#### Zoning & Subdivision Committee Thursday, April 12, 2018

# **Staff Report – Darby Braeside**

# DARBY BRAESIDE PHASE 2 FINAL ENGINEERING PLANS STREET, STORM, AND GRADING PLANS 2018

STANDARD DEED RESTRICTIONS FOR UNION COUNTY:

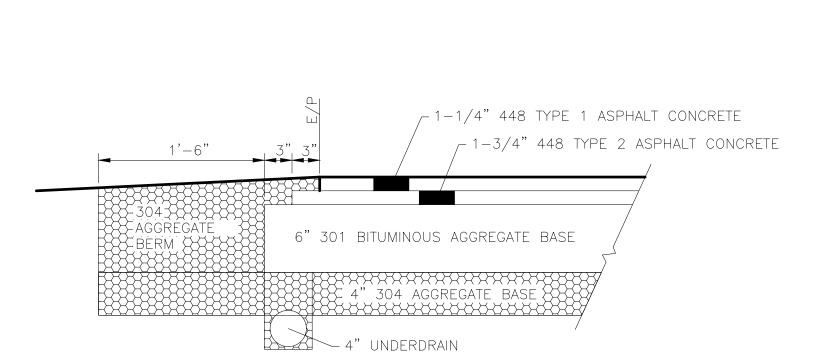
- 1. In reference to the Union County Standard Deed Restrictions on Sheet 2: Note #4 needs revised, as the storm infrastructure outside the right-of-way will be maintained by our office and Soil & Water Conservation District through the Ditch Maintenance program. Remove Note #10. Note #14a needs revised per the first comment.
- 2. Define all easements by general type, providing information regarding permitted occupants, use, restrictions, etc.

- 1. In reference to the Union County Standard Deed Restrictions on Sheet 2:
  - Note #4 needs revised, as the storm infrastructure outside the right of way will be maintained by our office and USWCD through the Ditch Maintenance program.
  - o Remove Note #10
  - Note #14a needs revised per the first comment above.
- 2. Define all easements by general type, providing information regarding permitted occupants, use, restrictions, etc.
